# Development Application **ACCESS REPORT**

**Reference Number:** 23180

**Site Address:** 5 Mary Street, Northmead NSW

This Access Compliance Report is to accompany a Development Application (DA) for the development proposed at **5 Mary Street, Northmead NSW**

[Image description: Plan of Lower Ground Floor Level above shows the provision of Accessible parking spaces]

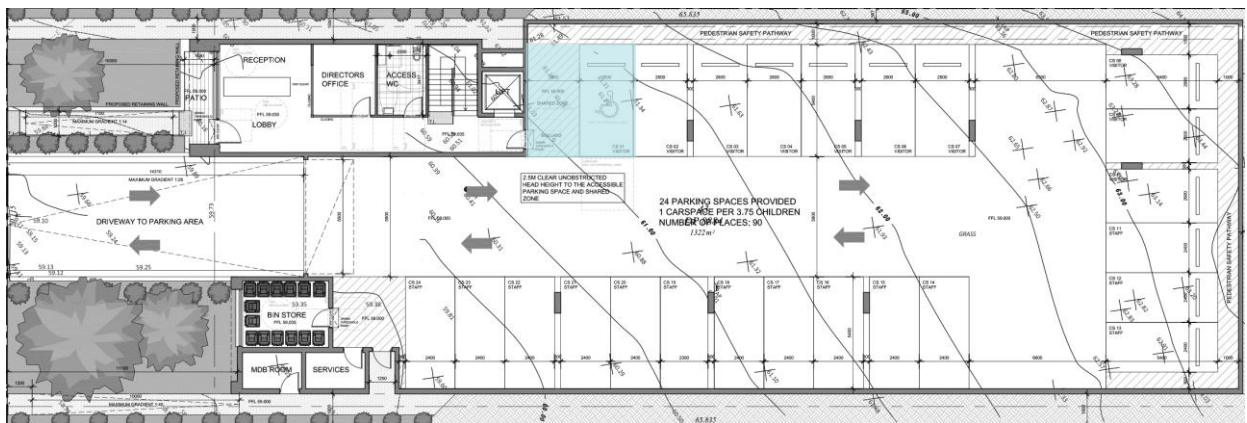
Complies

Total number of Accessible parking spaces required / provided in the development = 1
